Tech. Information No.	2117 / 2017
Subject:	FPA-5000 firmware 2.19.6 issue: Panel does not detect input state change on FLM-420-O1I1

Short Description:	State change on input of FLM-420-O1I1 is only detected when the neighboring output is assigned an address
---------------------------	---

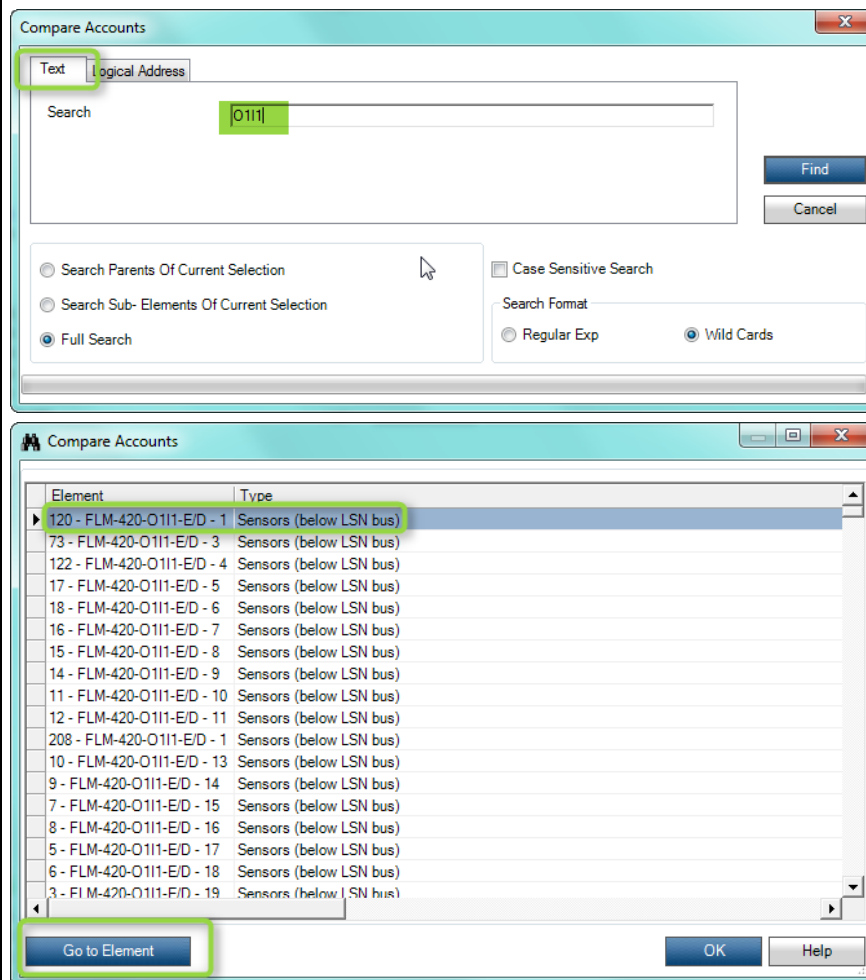
With FW 2.19.6 a state change on the FLM-420-O1I1 input is only detected by the panel when the neighboring output is assigned a logical address.

Please check new “2.19” configurations and also configurations upgraded to “2.19”

In the RPS 2.19 configuration simply assign an address to the output.

With the address assigned to the output and the configuration loaded into the panel, the panel will now detect the state change on the FLM-420-O111 input.

To locate an FLM-420-O111 in your configuration use the search function, select the individual element and hit “go to element”
